Project Title: TOYOTA-STEEL CAR PORT-DEFERRED
SUBMITTAL

PLAN CHECK NO.: **040907 Rev 1 (PCR04115) SET: III**

RECHECK PLAN CORRECTION LIST

GENERAL PLAN CORRECTION LIST

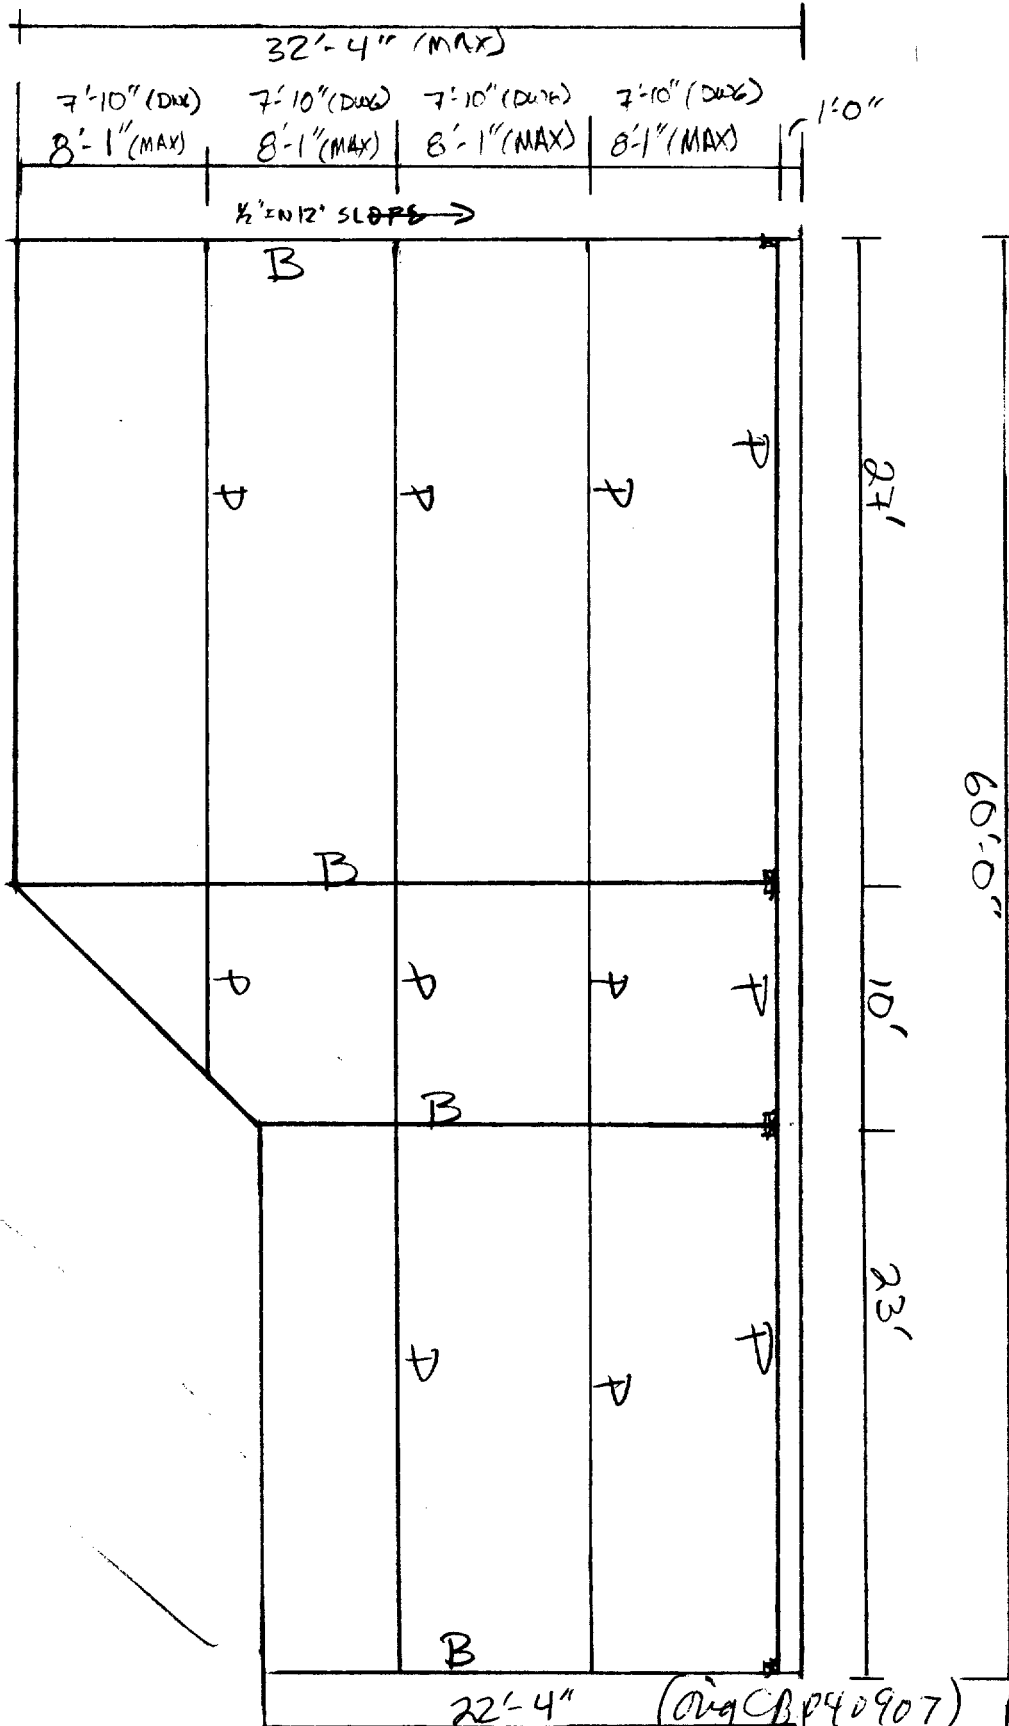
Please provide A fully
Dimensional site plan DRAWN to scale.
Show proposed + existing structures with
Setbacks.
